MEMORANDUM

To: File No. MIS08-000002, Sensitive Areas Decision No. 1
From: David Barnes, Project Planner
Date: February 29, 2008
Subject: **Glenealy Court – Wetland Buffer Reduction**
11406 NE 112th Street

Re: Review of the wetland and stream delineation report for the Glenealy Court 11-Lot Plat
City of Kirkland Permit No. PRE06-00069

SECTION B-B AT 5+00

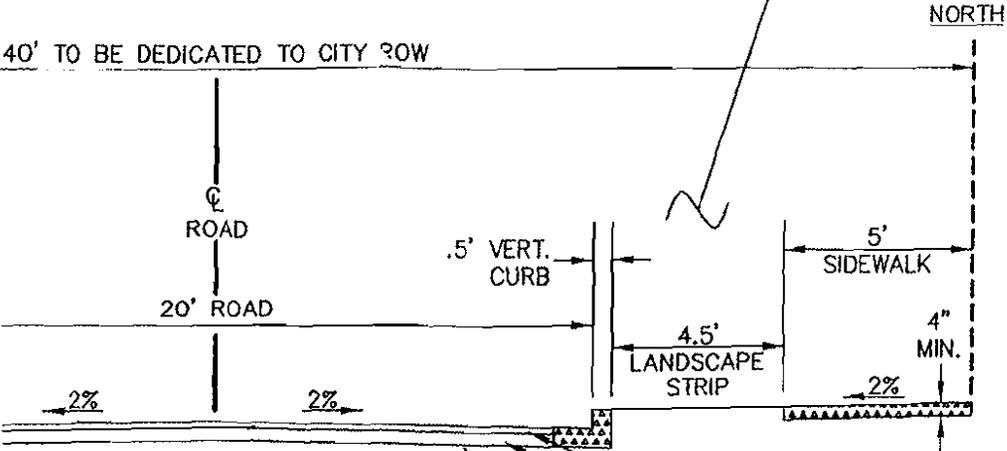
11. The new roadway will reduce my driveway by 5'-7". My truck is 18'-5" feet long and the new driveway will be 14'-3" long. (No Parking at my house)

13. Can you build a road with my preceding stretcher setback at 14'-3" feet, and what will that do if i want to remodel my house.

SECTION C-C AT 2+08

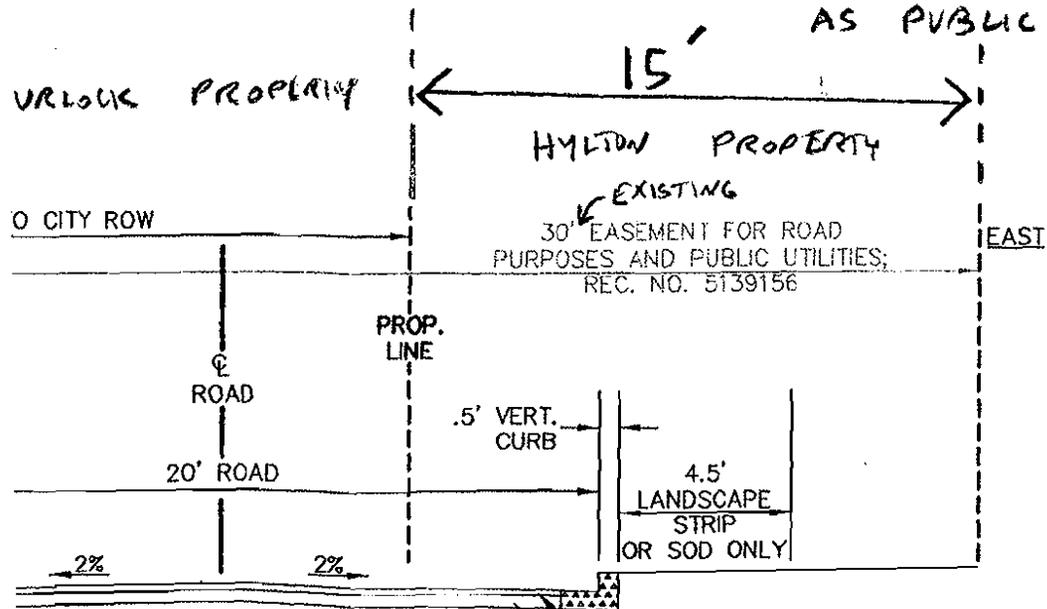
The second concern involves a 30-foot wide easement; the east 15-foot portion of the easement is the west 15 feet of your property. The primary purpose of this letter is to request a change to the easement. We believe there are 2 options regarding the future easement status. We seek your approval to terminate the existing easement on your property and convert it into dedicated City of Kirkland right-of-way OR convert it into a public use easement.

★ 15' STRIP PREFERRED TO BE DEDICATED OR GRANTED AS PUBLIC USE EASEMENT.

File Number (PSB07-00002)

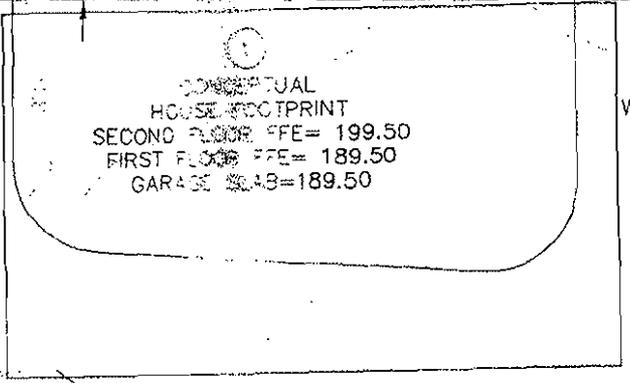
- (1) The New road that is going in front of my house By Hamish Anderson.
That will make my existing driveway about 14 feet long.
My truck is 18.5 feet long, making it impossible for me to park at home.
- (2) Clear cutting the up lot's will increase more water too my lot.
Can you put a storm drain stubout from the road to my lot for Run off?
- (3) Setbacks North Side of house is 2.5 feet and 14.7 Feet in front of house.
What will that do if I want to remodel my house ?

3. Per our survey, your measurements are not 100% accurate. The distance between the east side of your home and the common property line exceeds 20 feet, which is the required distance by Kirkland Land Use Code. Kirkland regulates building setbacks for a potential remodel. Distances from your home to your property lines will not change as a result of this project. For more information on setbacks, I recommend you schedule a Pre-Application Meeting at Kirkland City Hall.

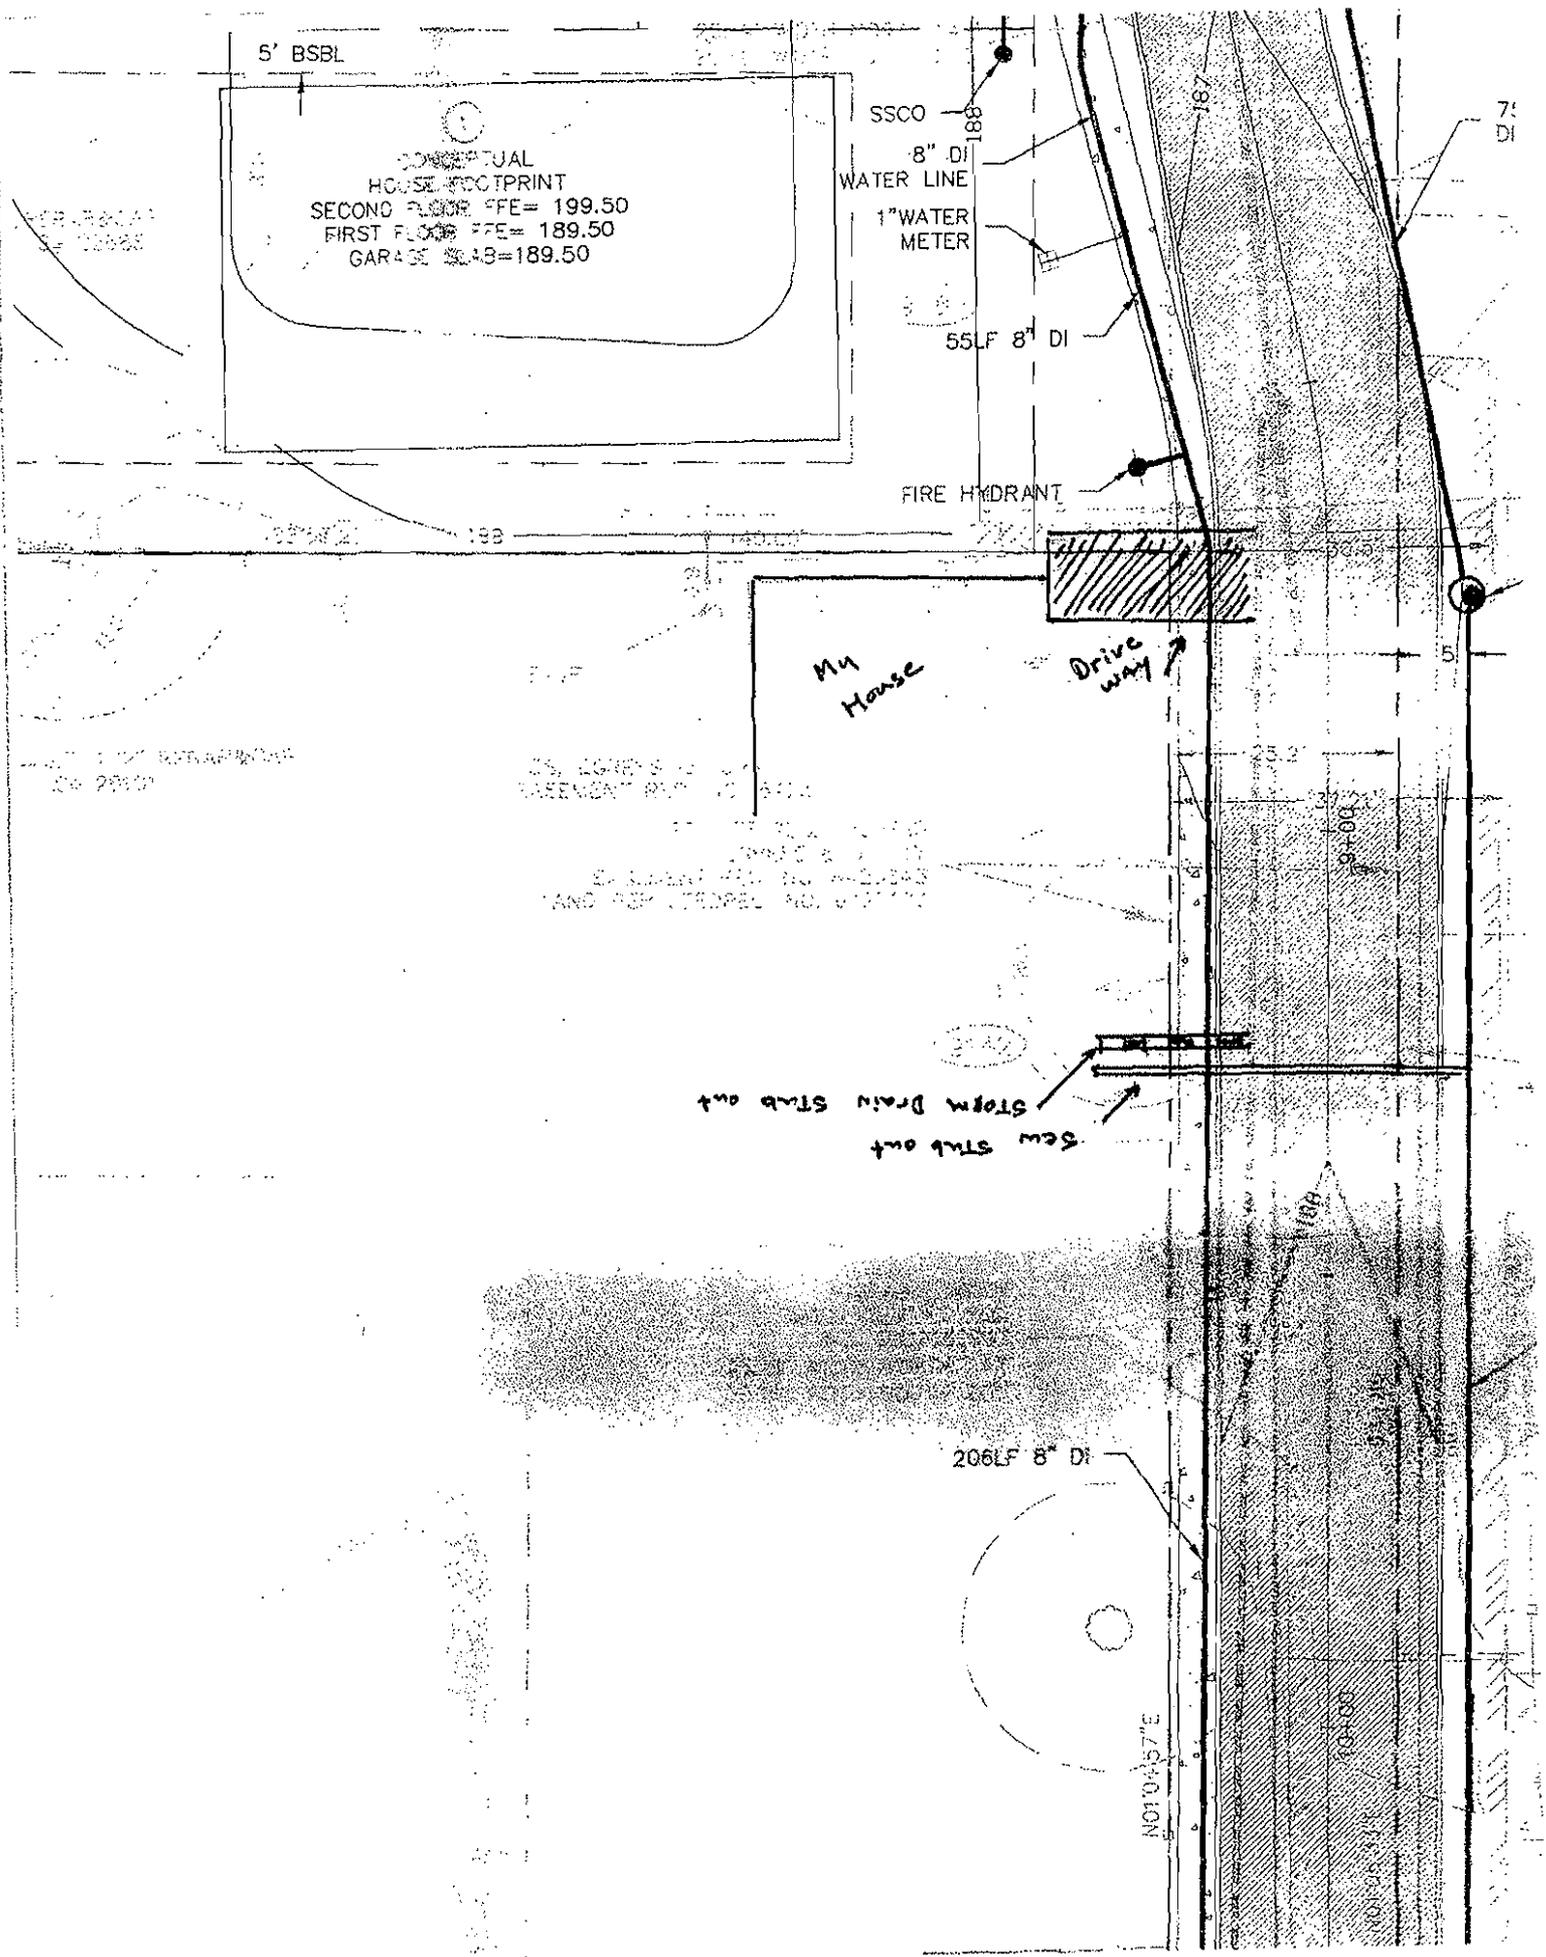
- a. Need a stub out for future Sewer / Storm drain connection to existing housing.

Sew stub out
 Storm Drain Stub out
